Manor Farm Propco Limited

Manor Farm, Poyle

SLR Project No.: 425.065619.00001

RE: HIGHWAYS S106 DISCUSSIONS – FOOTWAY / CYCLEWAY REQUEST

Figure 2.1 – Widths along Poyle Road within Highway Ownership

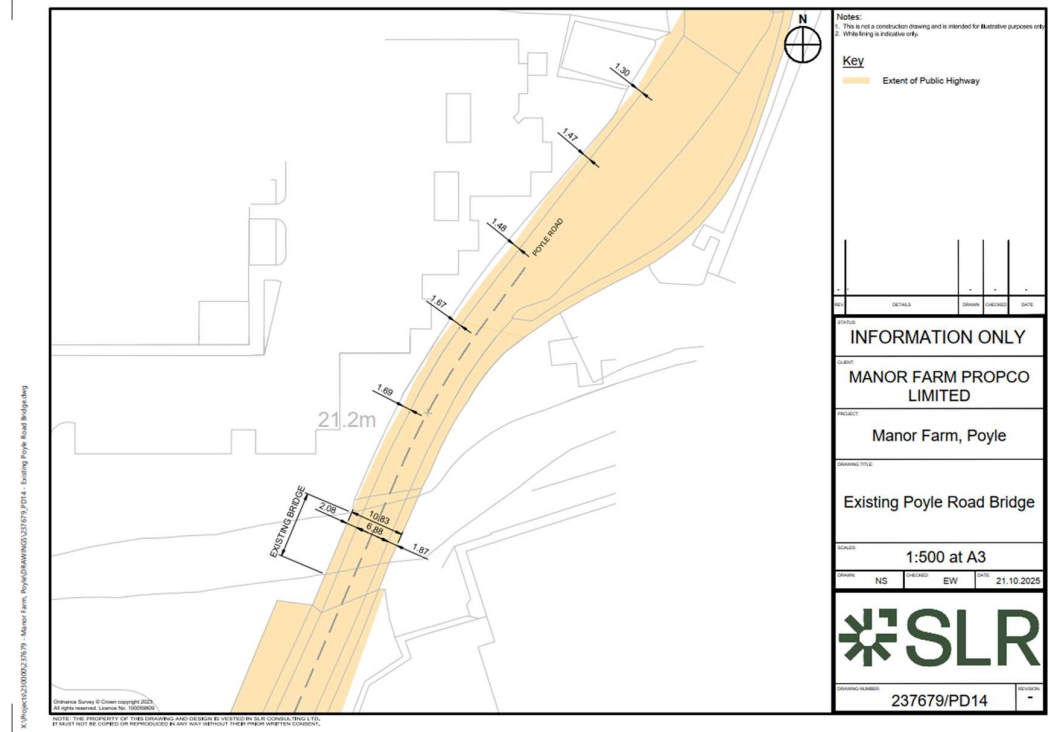
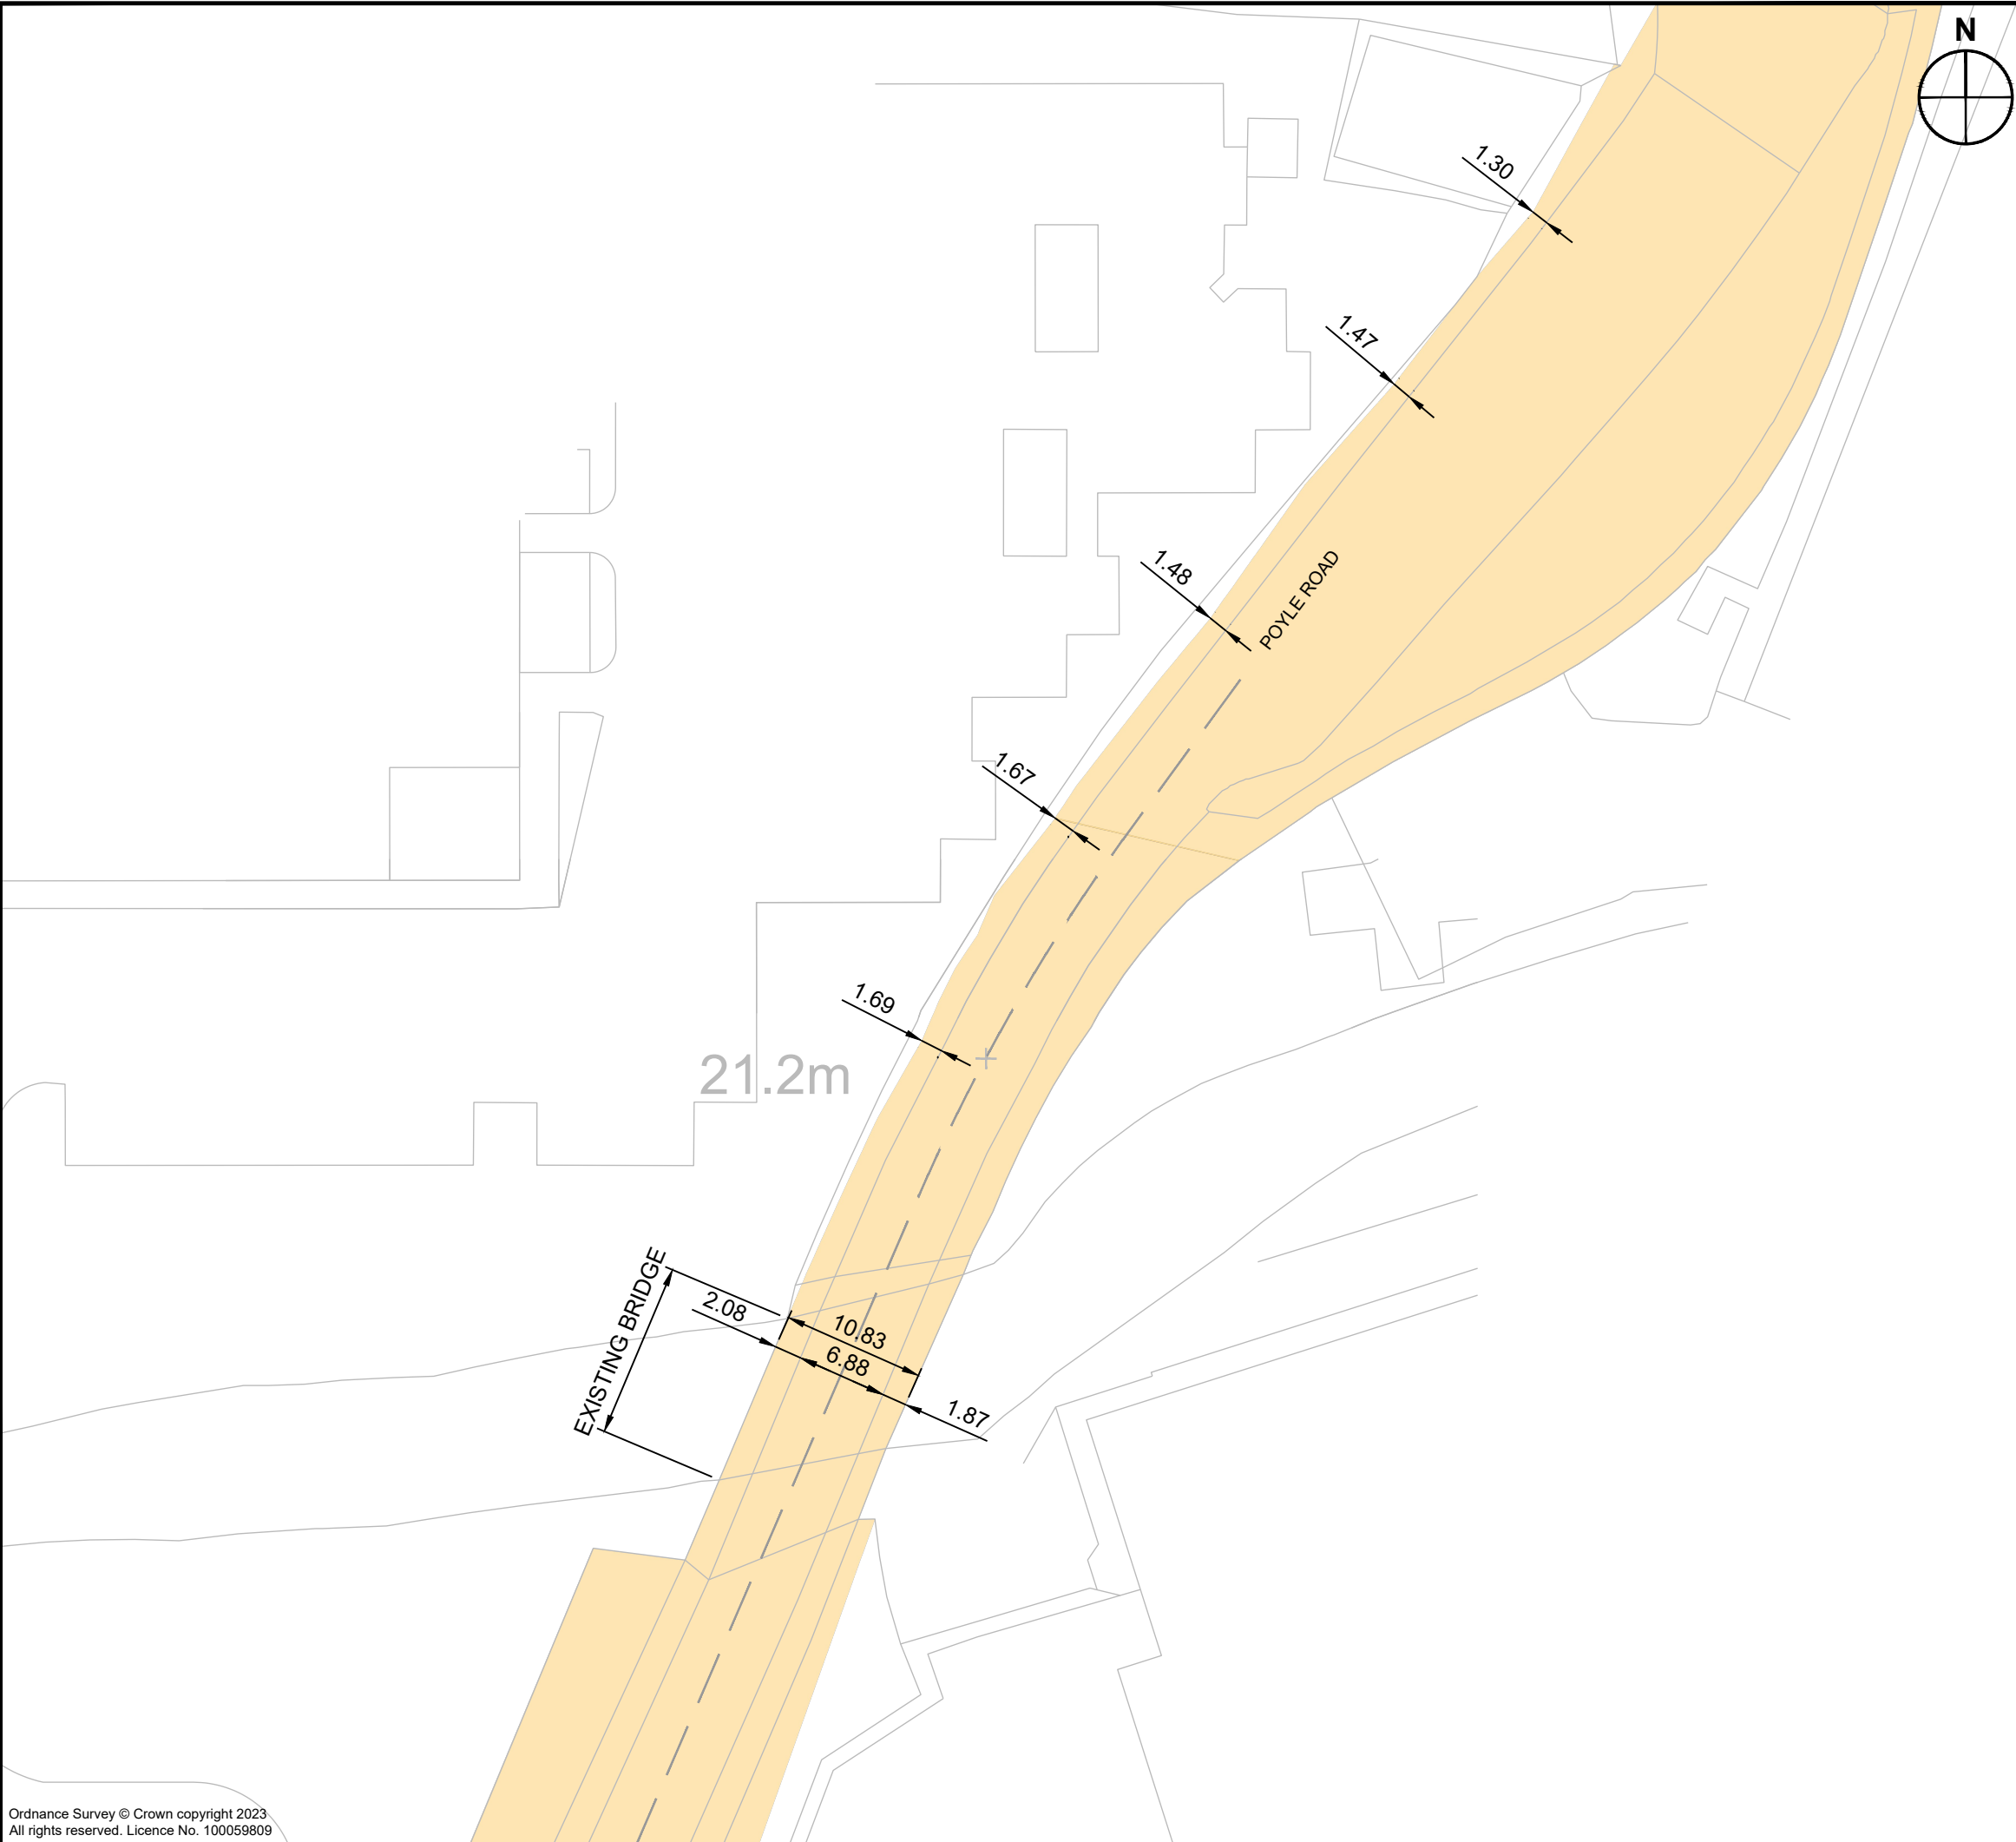
- 2.1 To the north, the requested footway/cycleway cannot be physically accommodated across the Hilton Way junction, or over the Poyle Channel bridge and within the verge on the approach to this bridge from the north.
- 2.2 SLR Drawing 237679/PD14 shows the width constraints at the Poyle Road / Poyle Channel bridge and to the north of the bridge and the existing shared used footway / cycleway. A copy of this drawing is provided in Figure 2.1 below and within **Appendix D**.

- 2.3 With reference to 5.1 of LTN 1/20 below, these widths are far below that required by the kinetic envelope of passing cyclists. Given the length of a reduced width facility could comprise up to 130m, this is considered a safety risk for passing cyclists and pedestrians - and would require cyclists to be put back on carriageway for this 130m extent.

- 2.4 The Pink Footway/Cycleway requested by SBC therefore cannot physically be accommodated. As this cannot be delivered, the rest of this TN considers the Yellow Footway/Cycleway only.
